## ADDENDUM NO. 2

**DATE:** October 8, 2019  
10/08/19

**PROJECT NO:** 190121

**RE:** AE Gage Center – Building A  
ADD-2, REV #2

SHEET NUMBER  
**A-100**

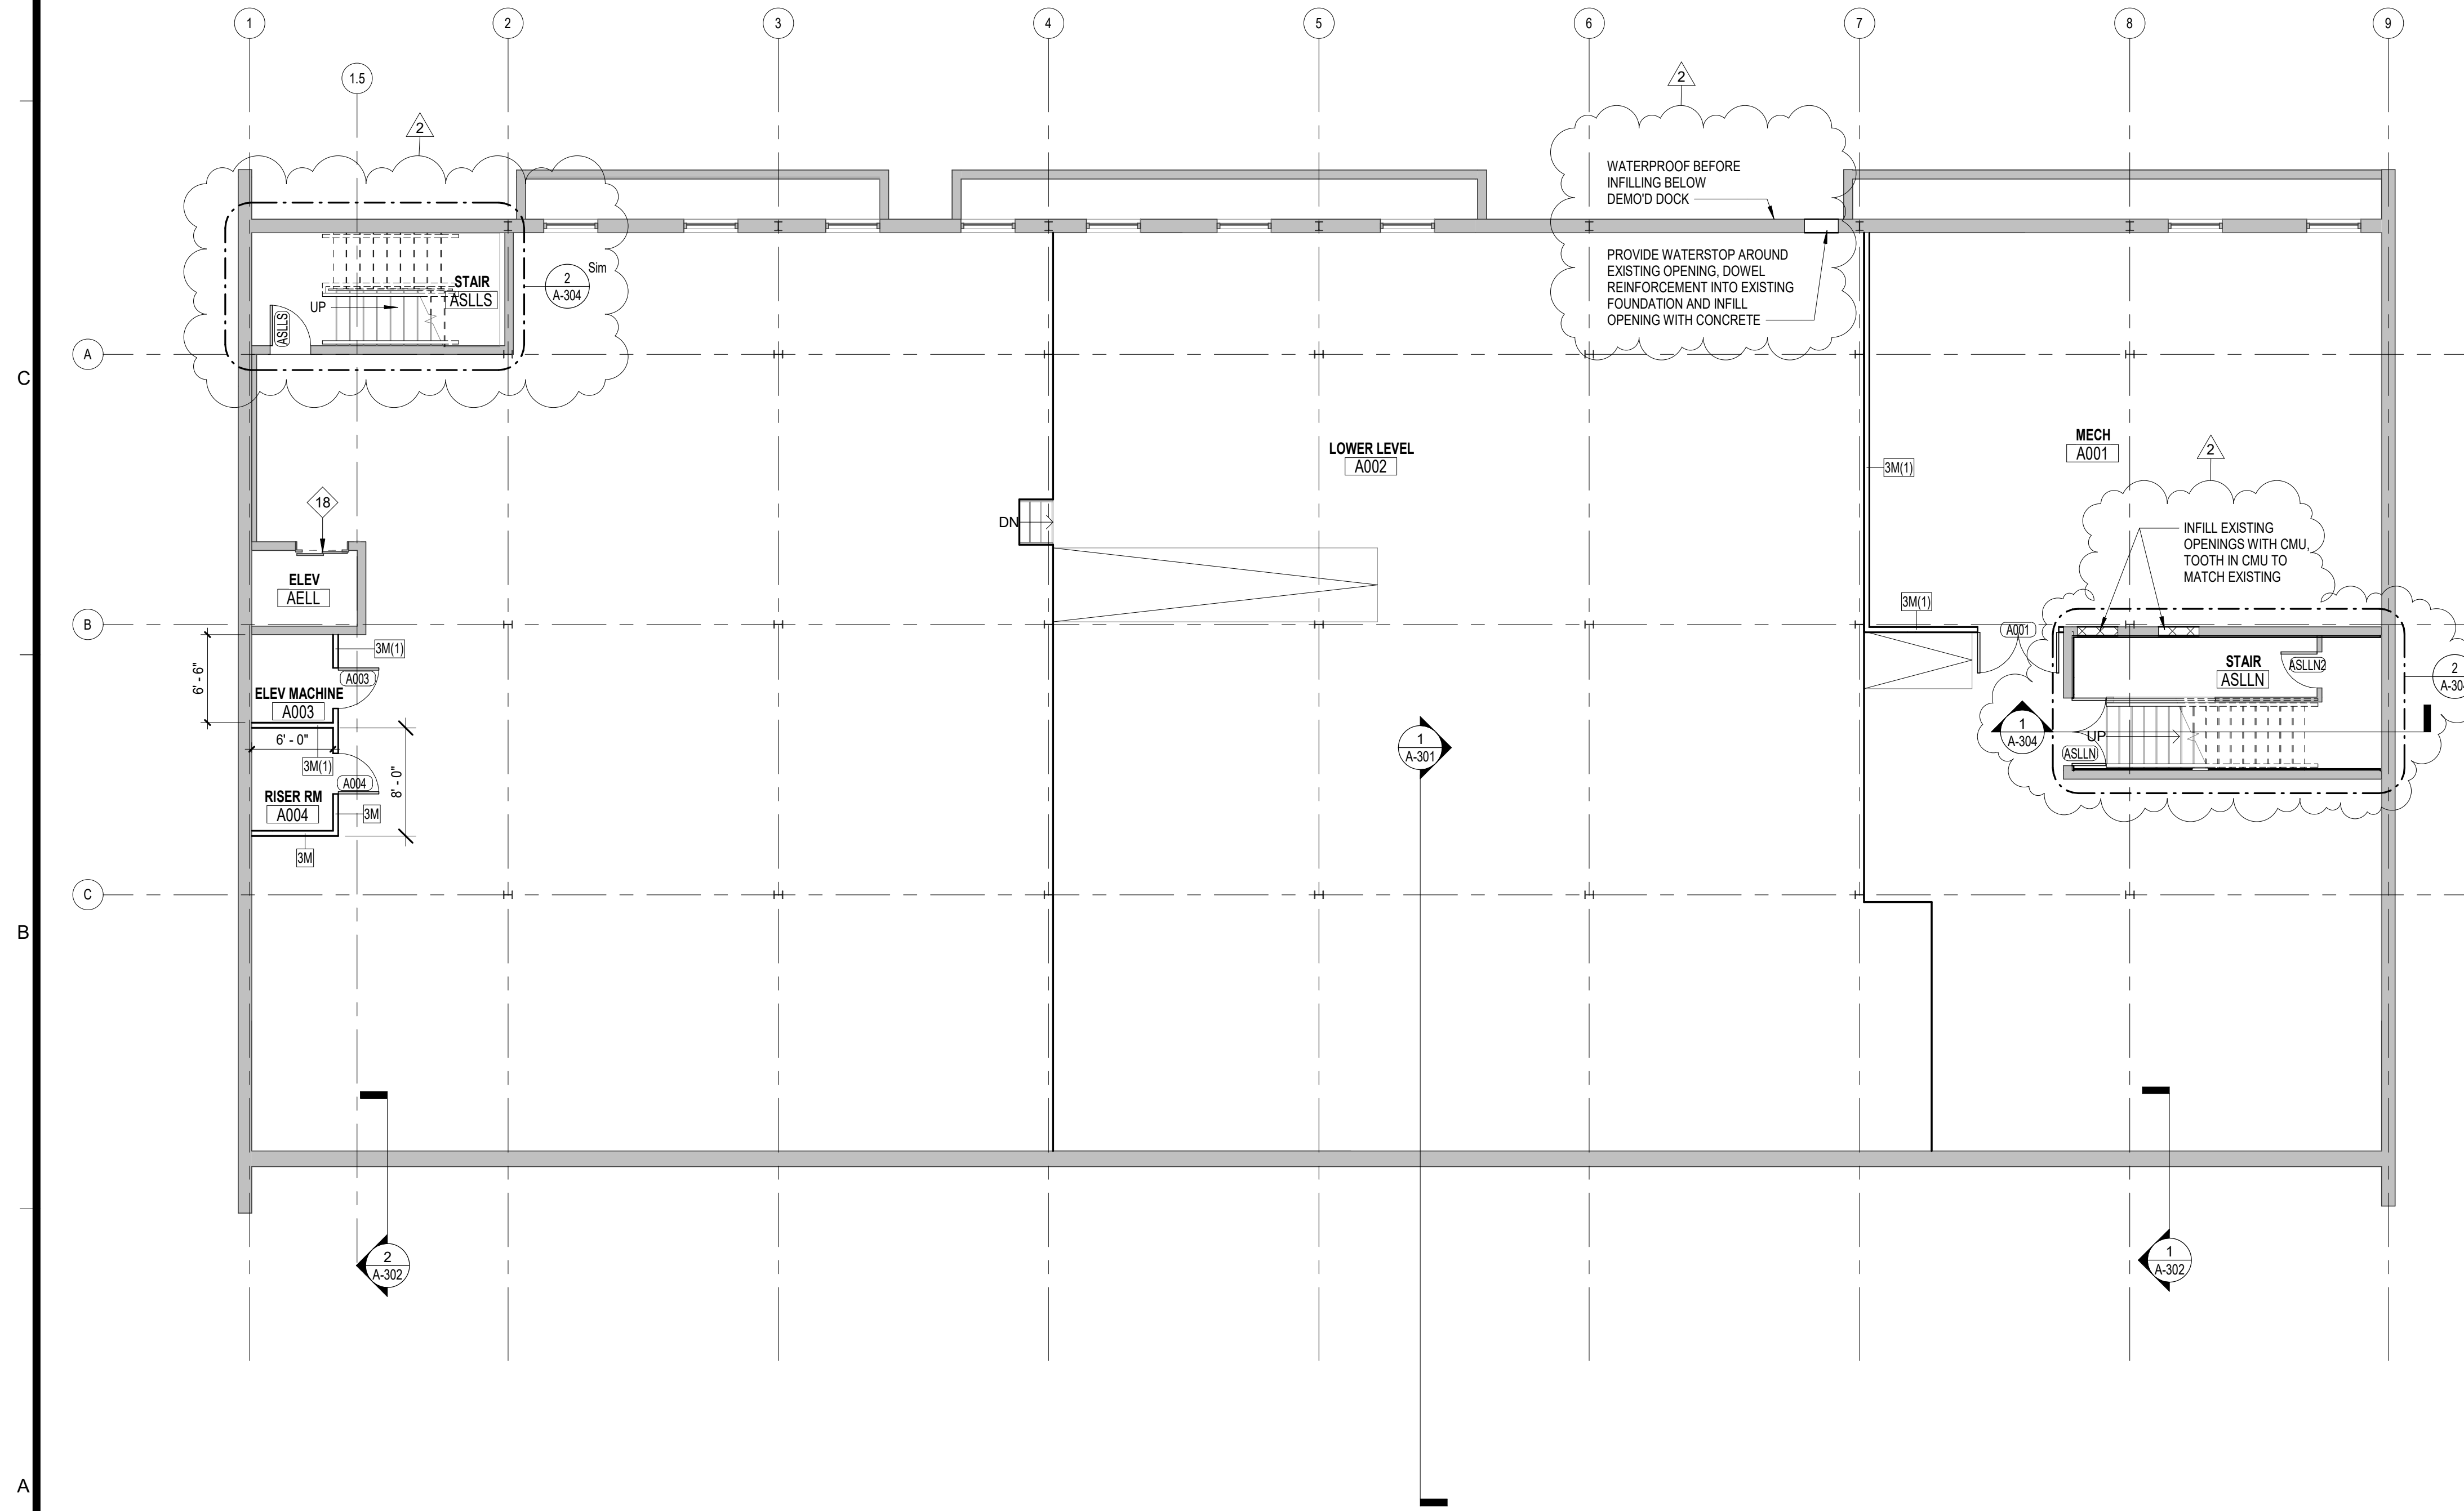
- A-1 Sheet A-100 – BUILDING A – LOWER LEVEL FLOOR PLAN:
  - A-1.A Add note at West wall opening, Provide waterstop around existing opening, dowel reinforcement into existing foundation and infill opening with concrete.

- A-1.B Waterproof West exterior foundation wall where dock was removed before backfilling.
  - A-1.C Infill both openings in the West wall of the North stair tower with CMU to match existing, tooth in new CMU infill.

- A-1.D Add section mark 1/A304 and callout 2/A-304 at North Stair.
  - A-1.E The South stair shall be marked as similar to the North stair. The South stair will need a similar handrail and/or guardrail as the North stair. The GWB finish is not required, paint existing CMU.

**SHEET NUMBER**  
 A-101

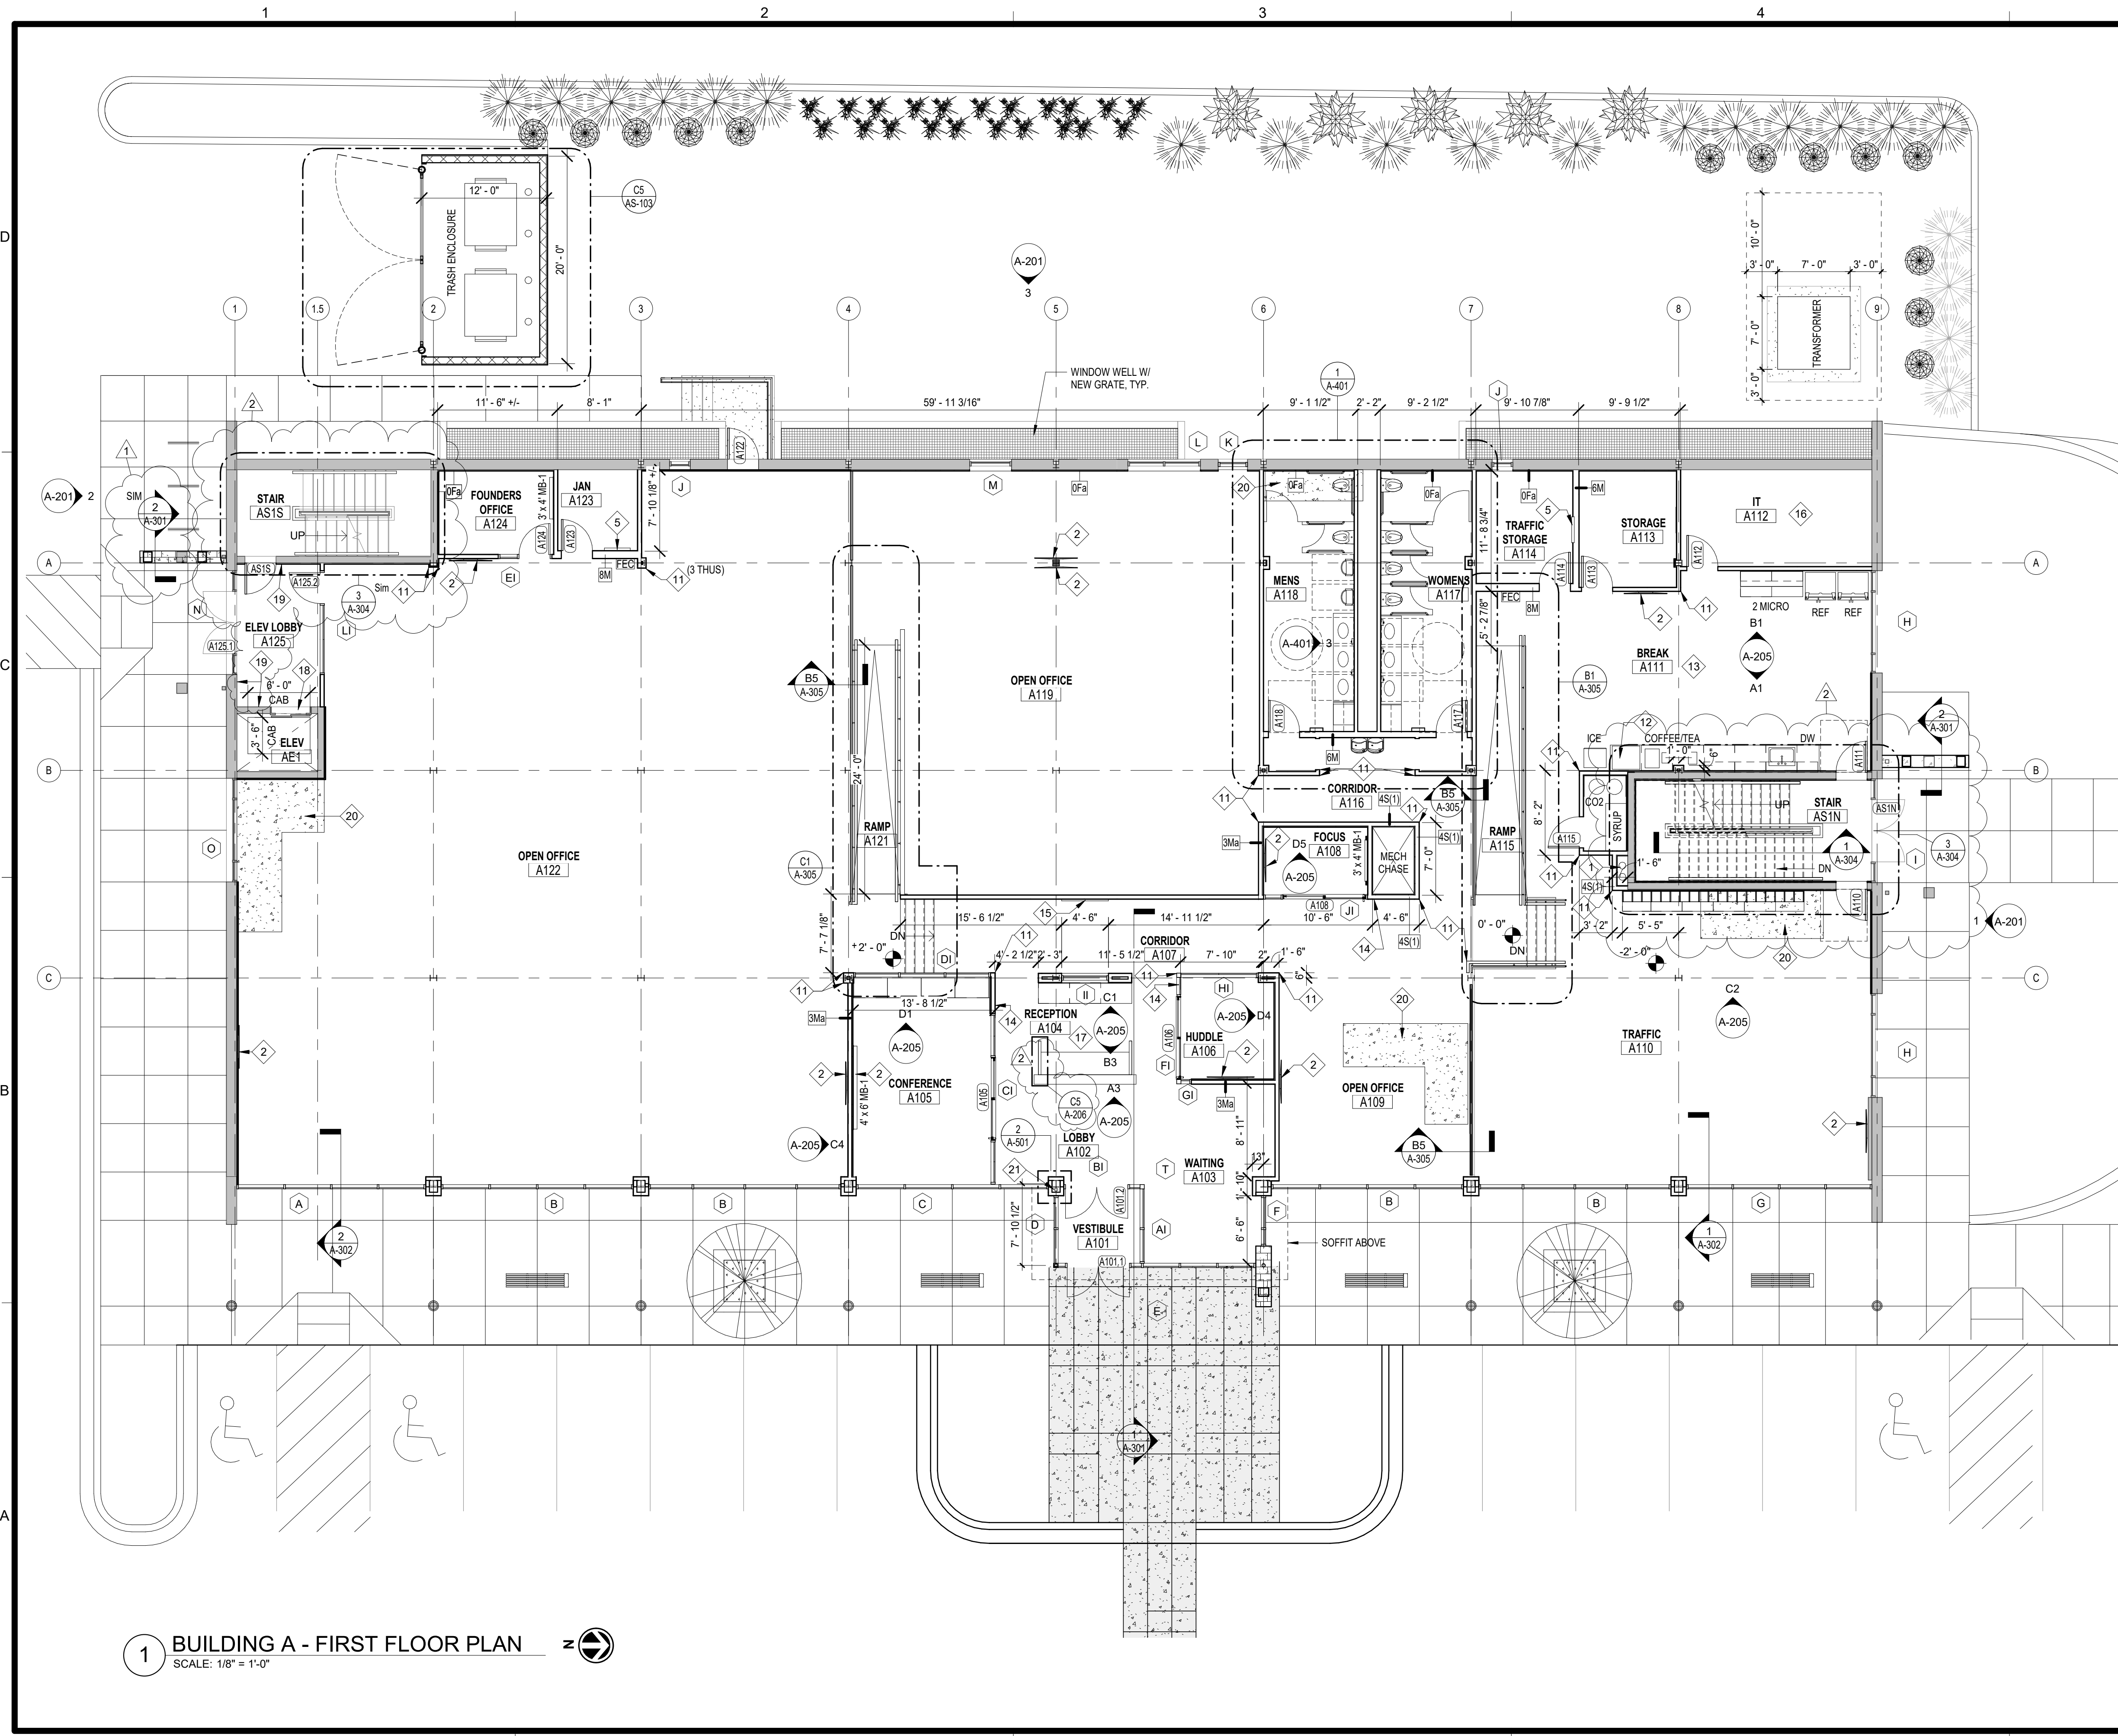
- A-2 Sheet A-101 – BUILDING A – FIRST FLOOR PLAN:
  - A-2.A Add section mark 1/A304 and callout 3/A-304 at North Stair.
  - A-2.B The South stair shall be marked as similar to the North stair. The South stair will need a similar handrail and/or guardrail as the North stair. The GWB finish is not required, paint existing CMU.

- A-2.C Add Detail callout C5/A-206 at end of Reception Desk.
  - A-2.D Add plan note symbol 19 for existing walls in Elev Lobby A125.
- A-3 Sheet A-102 – BUILDING A – SECOND FLOOR PLAN:
